Allnorth Information		VICTORIA GOLD CORP.	
Project #:	<b>19-PG-0305</b>	Client Project #:	
Document #:	<b>191029</b>	Client Document #:	
Document Rev. #:	<b>0</b>	Client Doc. Rev.#:	
Prepared By:	Jordan Smith, EIT	Client Contact:	Richard Tuohey
Reviewed By:	Don Williams, P.Eng.

Annual Physical Stability Assessment Report – Victoria Gold – Eagle Gold Project

**Figure 12: Heap Leach Facility Overview**

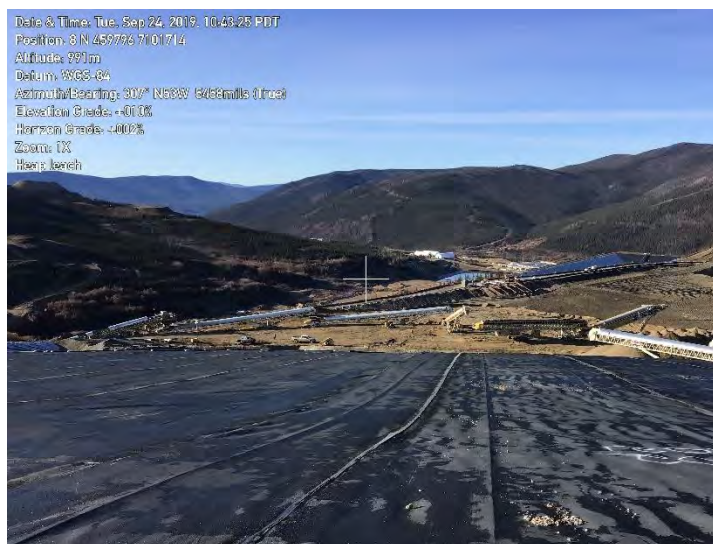
The Heap Leach Facility (HLF) is currently operational including the deployment of irrigation network and the placing of over-liner drain fill on the phase 1A pad area (Figure 12).

1. Continue to monitor the cut slopes around the perimeter of the HLF for erosion. Maintain the upper bench and remove sloughing material as required.
2. Install further ditching at the top of the temporary upper overburden stockpile area to control water flow and address scouring issue on the access road.
3. Consider re-shaping the temporary upper overburden stockpile to reduce risk of material sloughing down towards the access road.
